**IN RESPONSE TO
IFB 23-005
Town Hall Parking Lot Drainage
and Resurfacing Project**

May 10, 2023

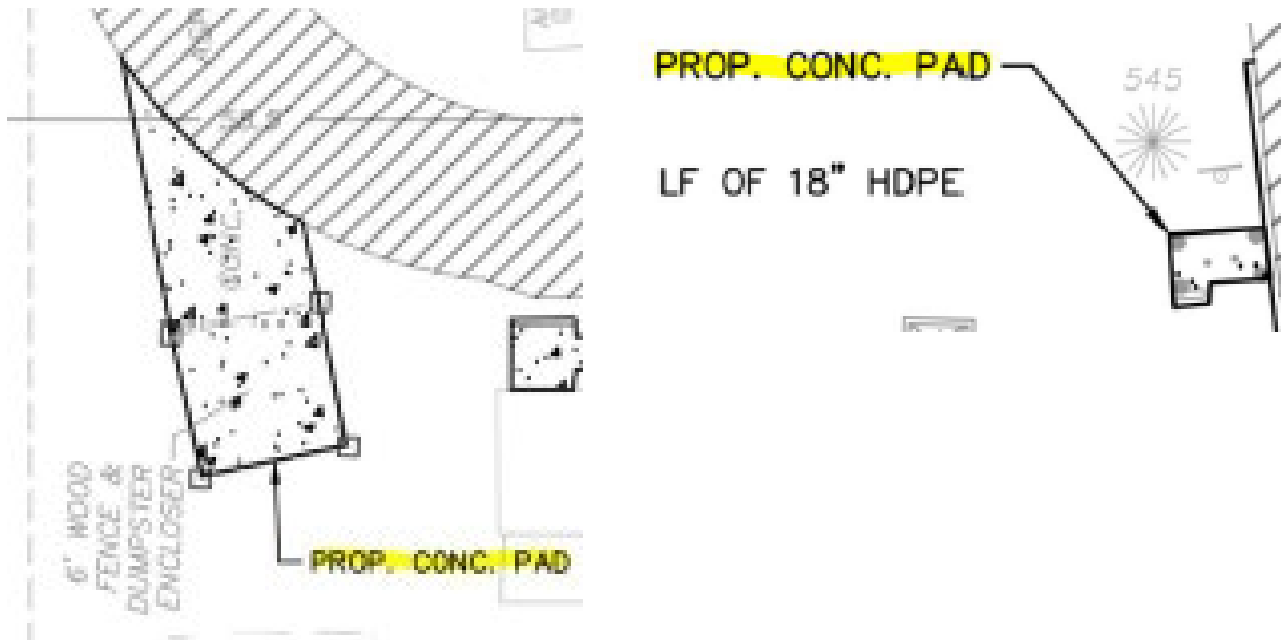
- 6. Question: Please provide details for the concrete pad. What thickness, concrete strength or if it has rebar or not? See figure below, Pg C300**

Answer: Concrete pad shall be 6" Concrete. Please refer to 'Standard Duty Concrete' detail on sheet C301.
